Motorola Solutions Technical Notification (MTN)

TITLE: APX/PCR RSM Cable Jacket separation/fraying exposing internal wires

TECHNOLOGY: Accessory - APX/PCR Remote Speaker Microphones

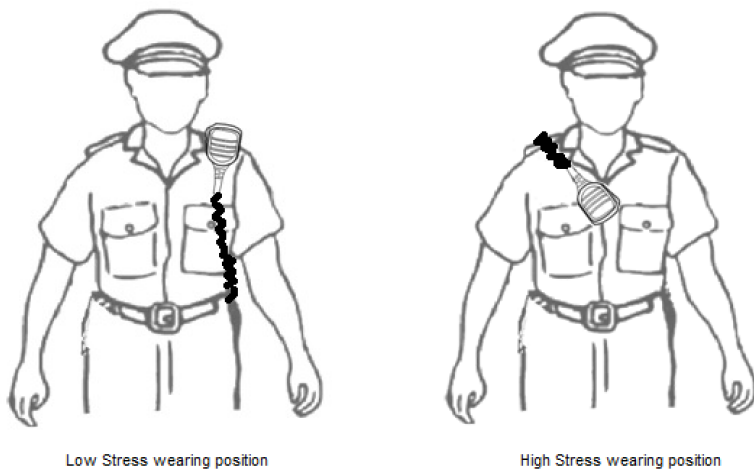
The RSM cable jacket tears or frays and exposes the internal wires. See the example picture below..

- the RSM cable black outer jacket develops frays that get worse with use
- the inner cable contents become visible
- typically occurs at RSM head or radio connector (GCAI) end or both, but can also occur in cable middle section.

Susceptibility to the cable jacket tear phenomenon has been significantly reduced by increasing the coil diameter which effectively reduces coil cord stress. Motorola strongly recommends RSM users to dress the RSM coil section of the cord in such a way that it does not get caught on uniform accessories and equipment or equipment worn on the person for optimal RSM service life.

The following lists show which model RSM is to be used for replacement with the larger coil diameter solution.
